Service Bulletin

Date: 18 June 2013

Subject: **Right hand cable retainer plate, front headlamp area**

Product: **B4 - ABS - MY 2013**

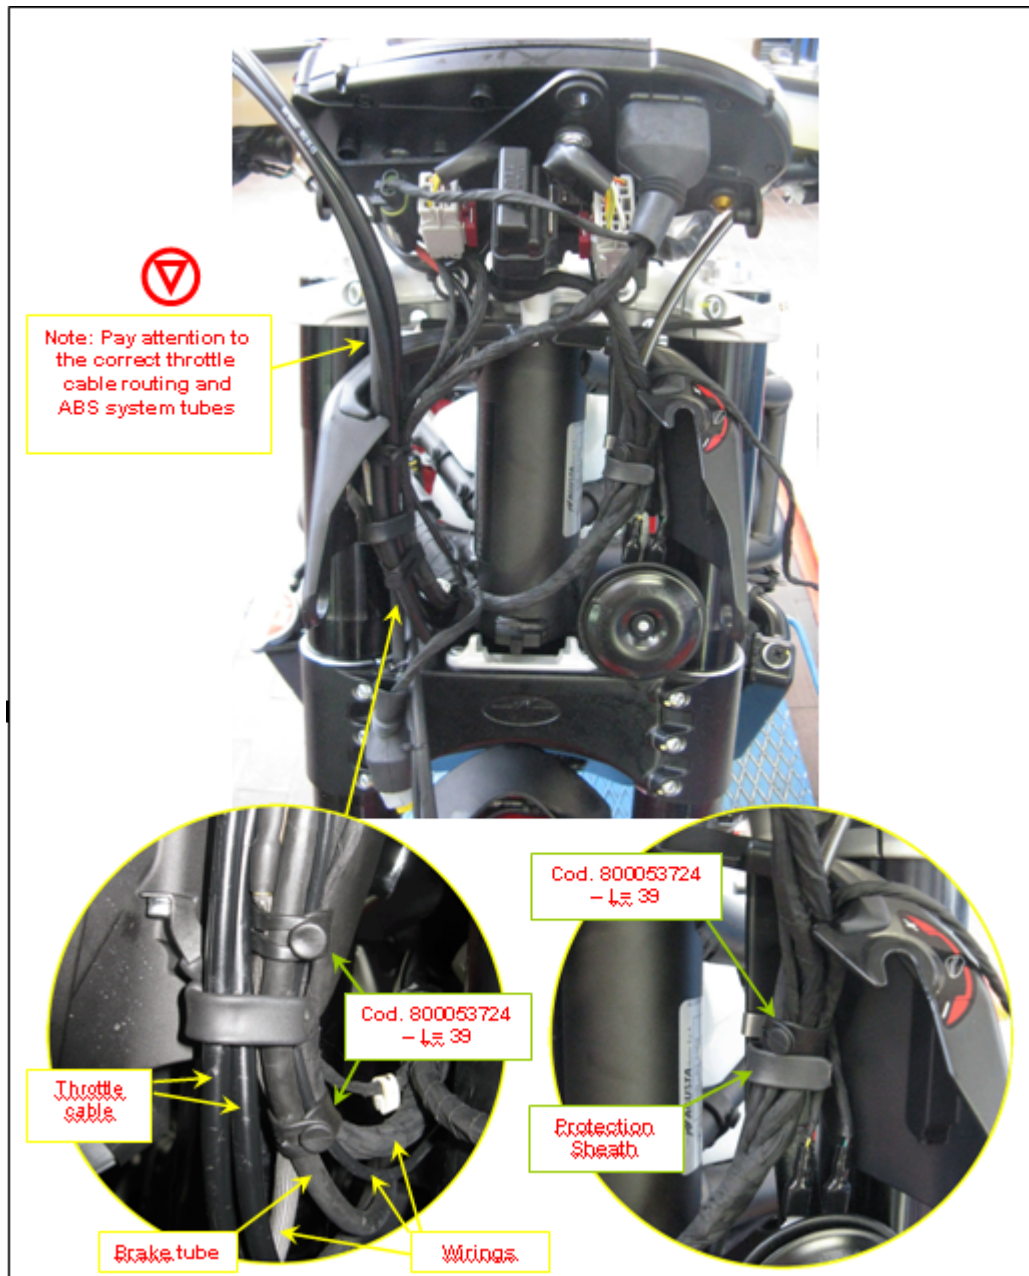
After a continuous product quality monitoring, we found a possible interference between cables and cable retainer plate fixed in the front headlamp area, so that could potentially cause a damage to the cables.

1 – The plate mounted on the right side of the headlamp support must be dismantled and covered with heat shrink or similar means, up to the edge , in order to avoid contact and damage to the wiring.

2 - two straps must be fixed as per attached picture so that they retain the wiring to the brake line

3 - throttle cables must remain free within the plate and should not be fixed with straps

On some bikes you already have the covered plate, in this case go directly to step 2.

4 – Once you completed the operation, check that the steering moves free and that wires or tubes can not be damaged in the steering limiter
